Official Transcript of Proceedings ACRST-3348

Advisory Committee on Nuclear Safeguards

531st Meeting

I now turn to Sam Armijo to lead us through the first items the ASME Code for Class 1, 2 and 3 piping.

Figure 2.15 Tensile properties at 288 C (550 F) versus strain rate for Pipe DP2-F29 (A106 Grade B carbon steel pipe)

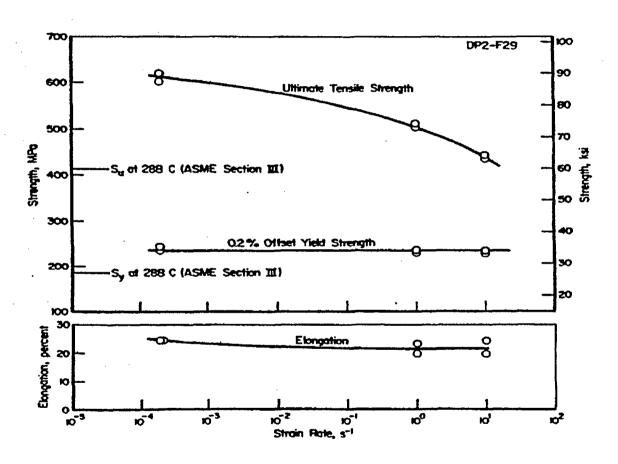
The next slide is just to show some of the data from Battelle. This is just one set of specimen data. If you look at the bottom it's elongation. At the top is showing ultimate tensile strength and yield. On the left side, the data points are equivalent to what you get on a quasi-static type of strain, a fairly slow strain rate, and these would be the basis that you would establish the ASME Code allowable limits. If you go over to where they test it at, at one inch per inch per second and ten inches per inch per second you get a fairly significant drop.

- Testing at Battelle has shown that certain carbon steel materials are subject to dynamic strain aging at temperatures greater than 300 °F.
- The dynamic strain aging results in a significant reduction in ultimate tensile capacity of the material (NUREG/CR-6226).
- Battelle testing of actual piping loops with large flaws under simulated seismic loads have shown a significant reduction in dynamic capacity at high temperature for certain materials (NUREG/CR-6233).
- Seismic strain rates can be in the range of concern (NUREG/CR-6226).
